## P23-01 Tractor Trailer Parking-Storage Area

Property Owner: AF Stan Real Estate LLC  
Applicant: Jay Bruckner  
Location: 5854 West Smith Road  
(Parcel Number 53-31C-02-007)  
Zoning: I-1 (Industrial)  
Request: Site Plan and Conditional Zoning Certificate approval for a tractor trailer parking and storage area

CITY OF MEDINA PLANNING DEPARTMENT

### DRIVE WAY ARRANGEMENT

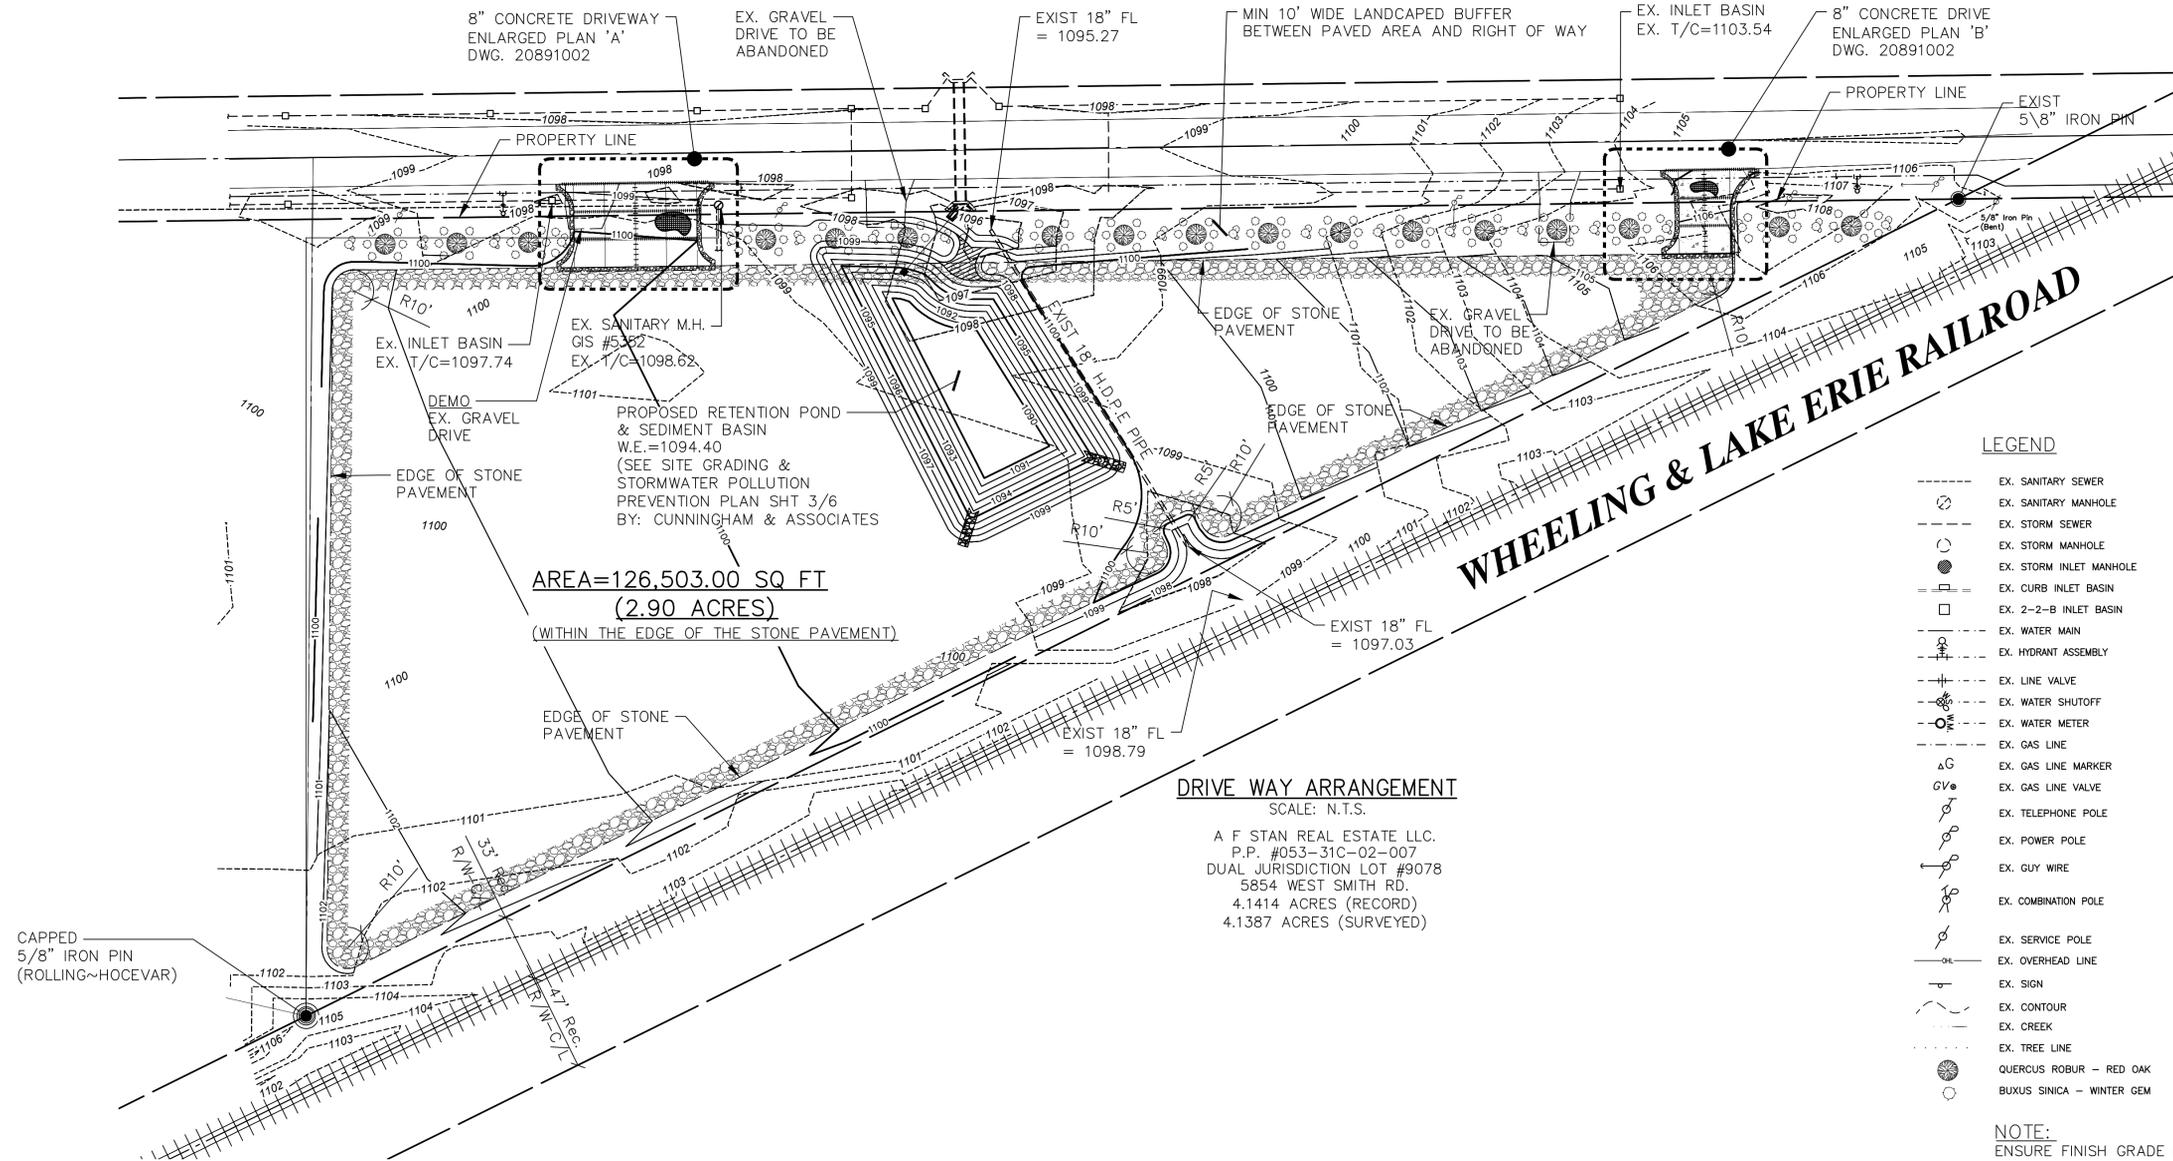
1. As submitted, we will not be able to approve this project. A storm water management analysis is required. Due to the size of the parcel and the site plan indicating the extent of the proposed parking area, a storm water detention basin will have to be built on the site to accommodate the future storm water runoff. Though the storm water management analysis is not required to be completed prior to Planning Commission approval, it is noted here because the location and size of the detention basin will affect the overall site plan.

3. The driveway aprons must be concrete.
4. Per City Codified Ordinances Section 1145.10 DRIVEWAYS TO PARKING AREAS the maximum driveway width at the right of way in an industrial area is 60 feet. The plans show a width of 65 feet.

Access and Circulation – The proposed site includes two access drives with concrete aprons off West Smith Road. Section 114510(e) requires that access drives must be between 24 ft. to 60 ft. wide at the right-of-way and a maximum of 120 ft. wide at the curb line. Access drives have been revised to meet the required widths.

Further noted is a requirement for driveway aprons to be constructed with concrete and compliant with access driveway width requirements. Plans have been revised to incorporate concrete drive aprons with appropriate widths.

### LIGHTING ARRANGEMENT

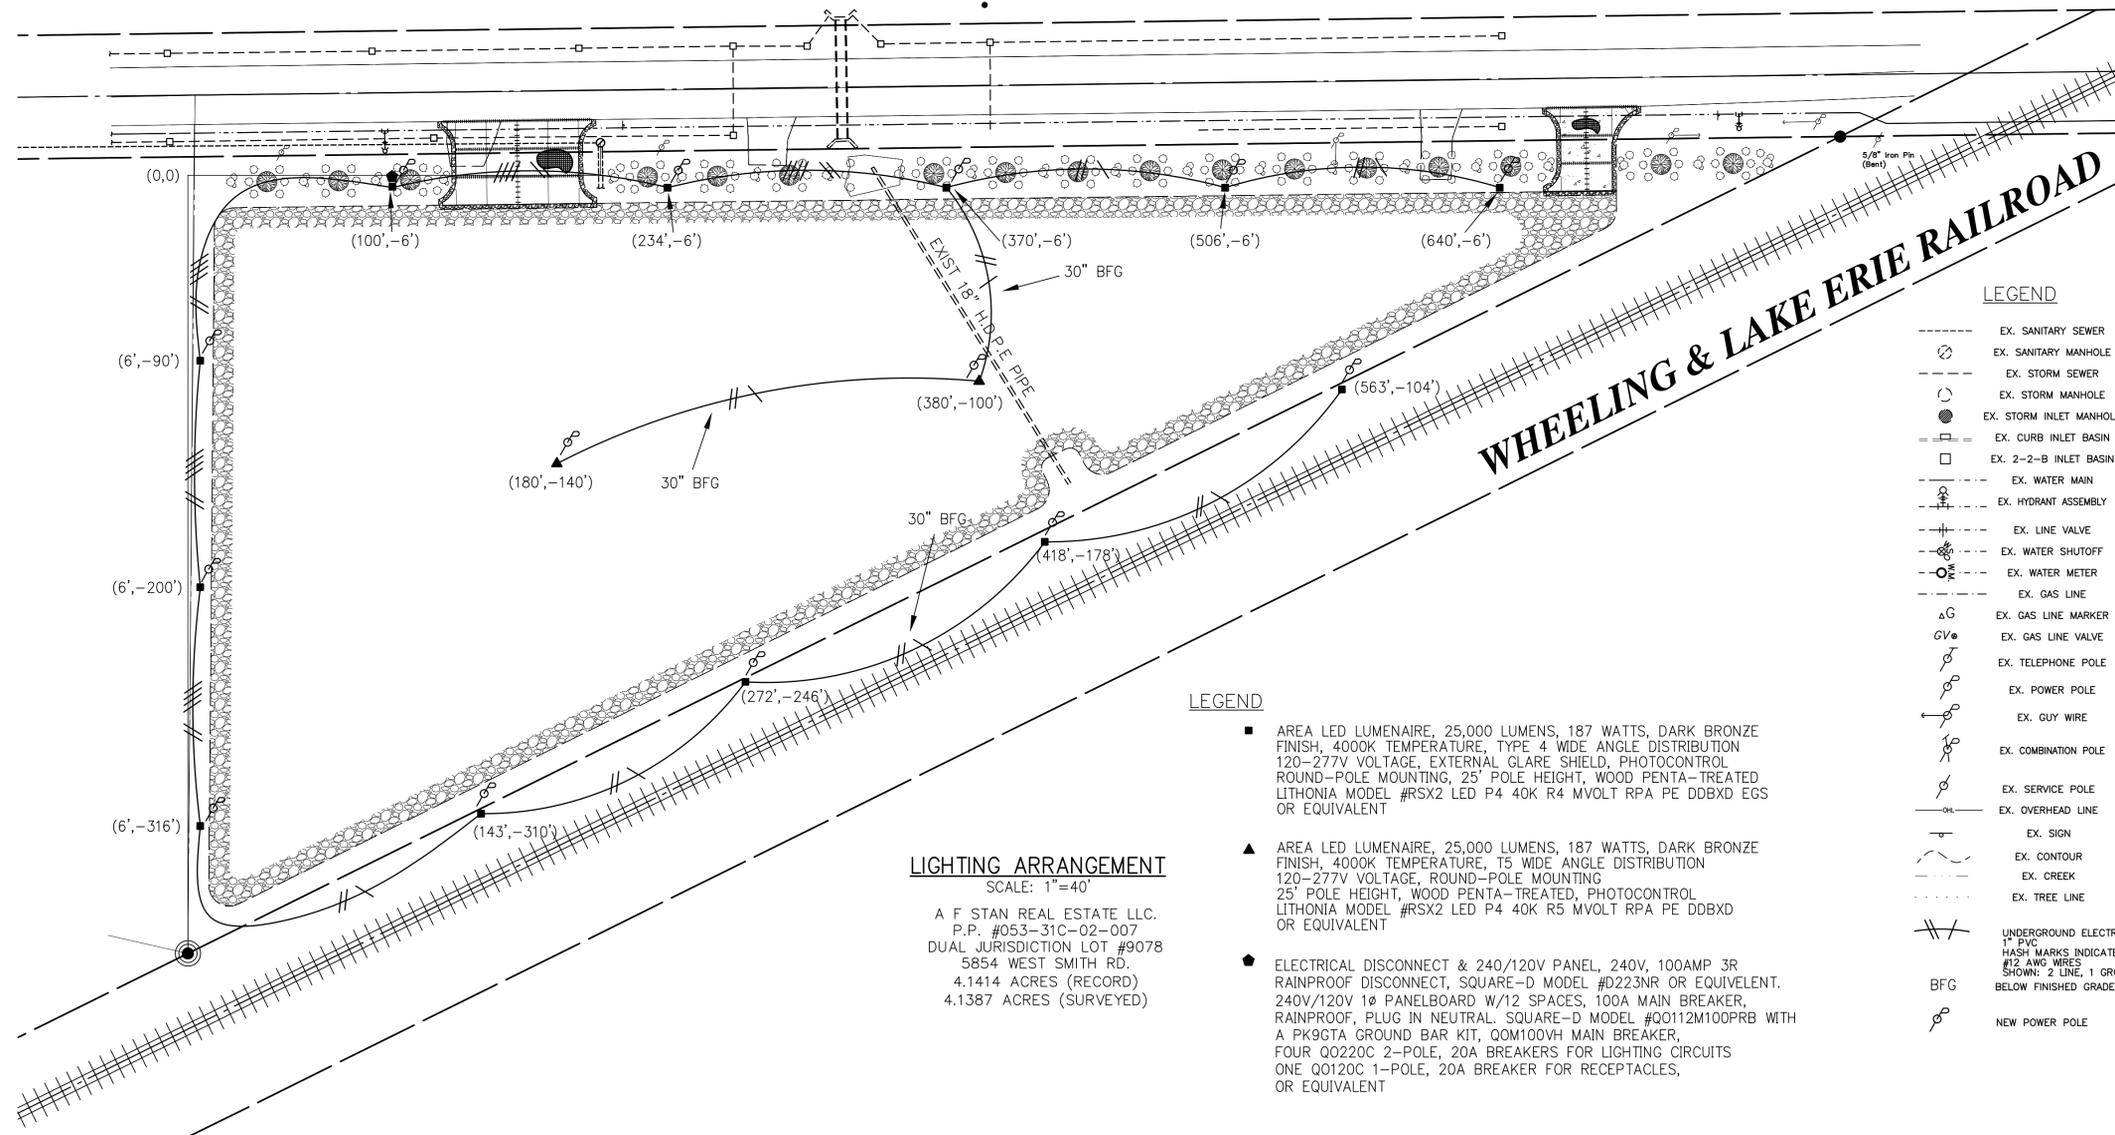
Section 1145.09 requires lighting to have a maximum height of 25 ft. and incorporate a full cut-off fixture that shines straight down. On the "Lighting Arrangement" page of the plans, lighting has been noted as 25 ft. in height with a Lithonia Model #RSX2 fixture, which appears to be a full cut-off fixture.
